# Westerly – Preliminary Plat No. 3 - 9<sup>th</sup> Review

To: Heidi Majerik, Erie Land Company  
 From: Aly Burkhalter, Planner  
 Date: April 24, 2024  
 Re: PP-001297-2023 Westerly Preliminary Plat No. 3 – 9<sup>th</sup> Review  
 cc: Kelly Driscoll, David Pasic, Jonathan Williams, Luke Bolinger, Kathy Kron, Jesse Ascunce, Ryley Gross, David Frank

### Development Review Team & Referral Comments

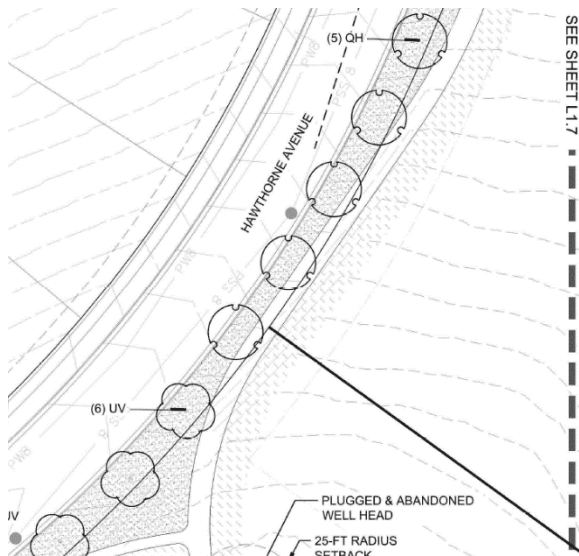
PW: Show wayside locations on Trails Plan and clearly denote distance between each wayside. An additional wayside is required in the vicinity of the intersection of Hawthorne Ave and Chestnut Ave. Please note that these locations will be required at time of Final Plat.

PW: Completed. Ensure wayside located near Chestnut and Hawthorne does not conflict with school site. The north side of Chestnut may be a more appropriate location.

Response: Waysides are being shown on the trails plan

Response: Wayside has been moved north of Chestnut.

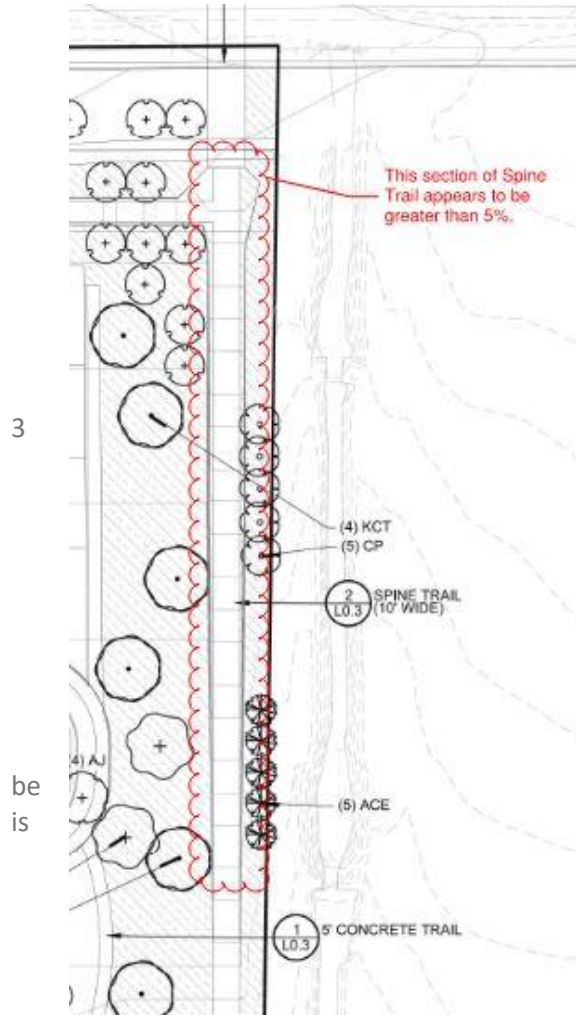
**The Spine Trail appears to have a running slope of greater than 5% in the NE corner of the development, just South of Erie Parkway. See below.**

Response: the intent of the grading is to show that ADA can be met and we believe we have done so. Final Grading and design for this will occur with the construction Documents and will meet Town and ADA grading requirements.

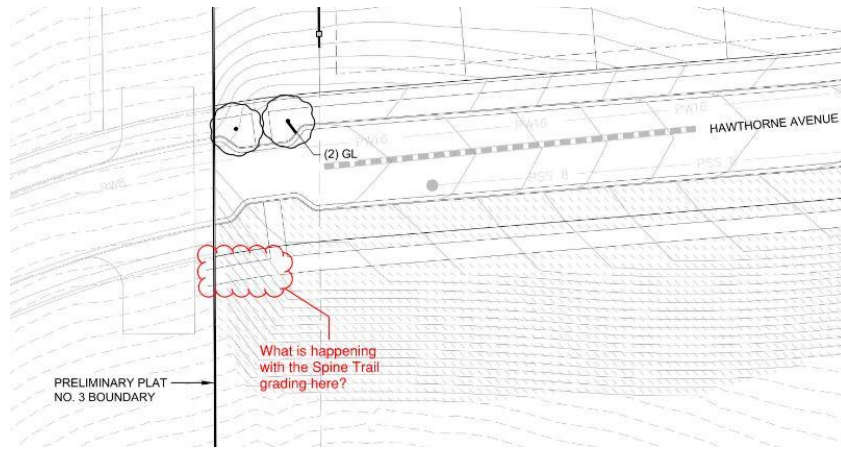
There appear to be grading issues in the SW corner of Sheet L1.6. See below.

TOE: Even though the sidewalk connection segment has been removed, the grading needs to be corrected to allow for an ADA compliant connection to be made when the property to the west (the future park site) develops.

TOE: The grading at this location needs to be designed based on existing grades. There is no timeline for improvements to adjacent properties. Grading needs to accommodate a connection without the need for significant changes on either parcel.

Response: The construction of the land within Preliminary Development Plan No. will be contingent on the design and construction of adjacent properties to the west. During the final design of this area the existing contours will be different and will allow us to grade at a 4:1 max slope. If for some reason the parcels to the west are not developed before final design, a wall may be added to the western edge to accommodate maximum grades.

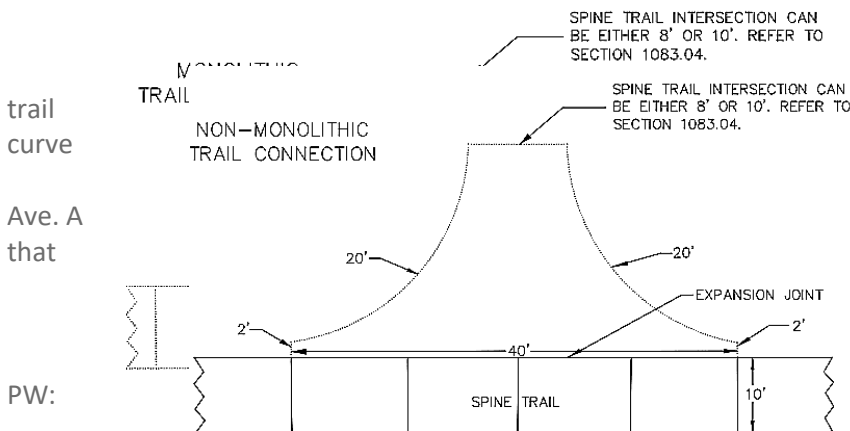
Grading for the Spine Trail appears to be incomplete on Sheet L1.8.

Response: The grading for the open space is correct, however the trail does not continue into Tract Z of Preliminary Plat 2. At the Town’s request the trail adjacent to Hawthorne in Tract Z was removed from the Landscape Plans. These plans have been revised to end the trail at the pedestrian crossing.

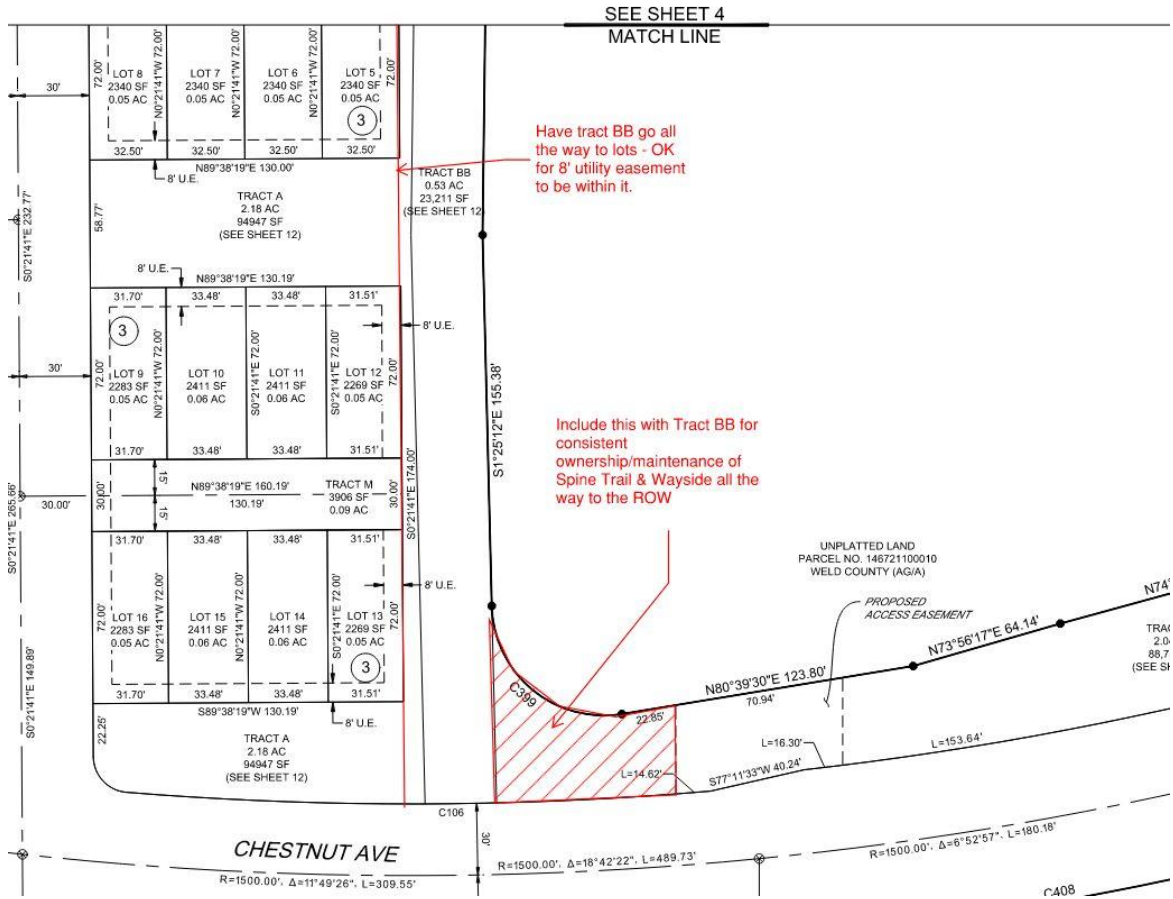
TOE: See edits to tract below. Also indicate Maintenance and Ownership as Town of Erie on the Tract Summary Chart on Sheet 2 of the Preliminary Plat.

**TOE: This is acceptable as shown for the Preliminary Plat, however final tract boundaries and access easements will be further reviewed when irrigation plans are provided with the Final Plat.**

Response: Submittal #6 comments were not returned to us prior to our 7<sup>th</sup> submittal. Tract summary chart and ownership and maintenance have been updated in landscape plans to reflect the latest plat.

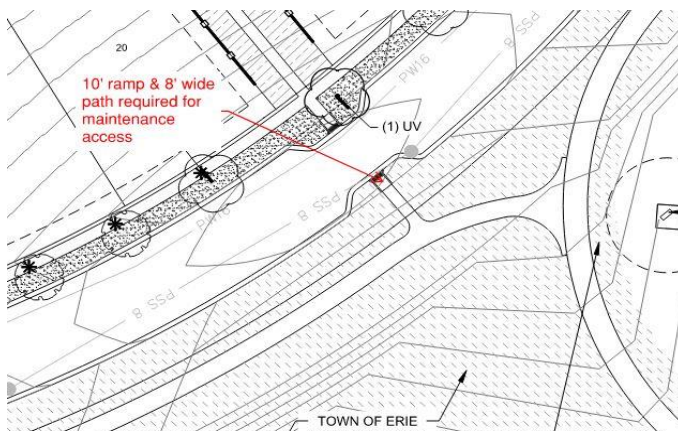
- Provide further design for the underpass at Erie Parkway and clarify intent to construct with this project.

Response: Grading in this area has been revised. Final details will be provided with the construction documents.

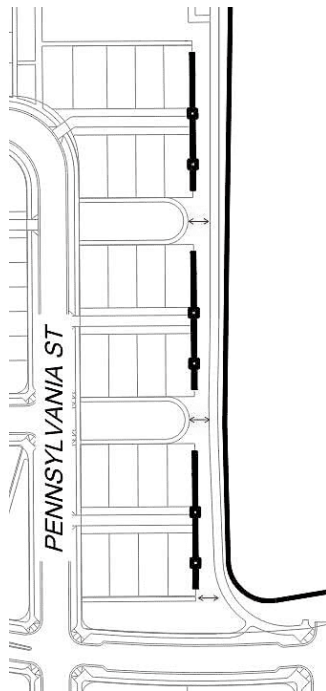
10. Provide pedestrian connections to the spine trail north of Chestnut Avenue. See locations below.

Response: As discussed with staff, the grading in these locations makes walk connections prohibitively difficult. In one case 8' of grade must be accommodated. To avoid social trails, developing to the spine trail we have screened the greencourts with evergreen plant material, which will also provide screening from the adjacent future commercial.
